96-10-1 CONVERTIBLE TOP LEAKS WATER AT TOP CORNERS

TECHNICAL SERVICE BULLETIN

Model(s): Lincoln-Mercury: 1991-93 Capri

Bulletin No.: 96-10-1

Fig. 1: Surface Of Division Bar To Clean

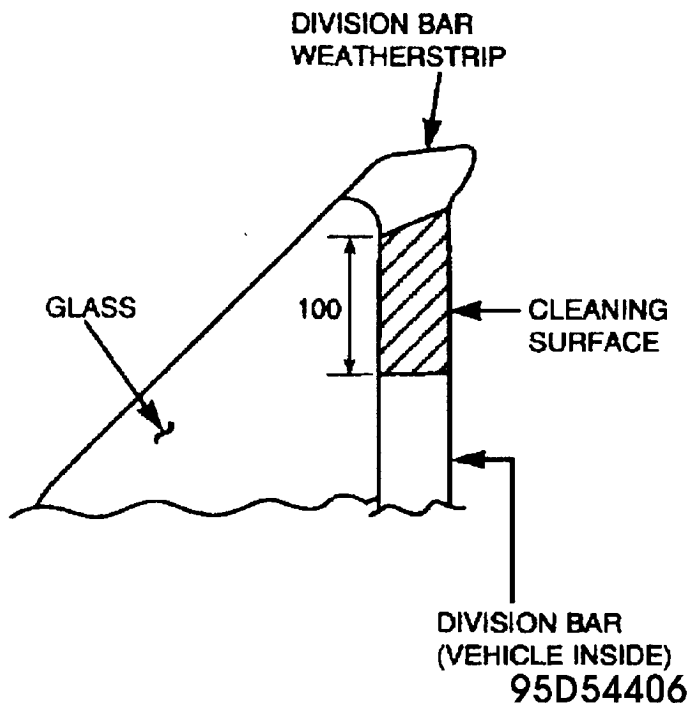
A water leak at the top corners of the convertible top may be evident on some vehicles. This may be due to the water catcher not diverting water in the proper manner.

1. Be sure the top is securely locked on the header. Clean the surface of the division bar with rubbing alcohol or wax and grease remover. Refer to Fig. 1.
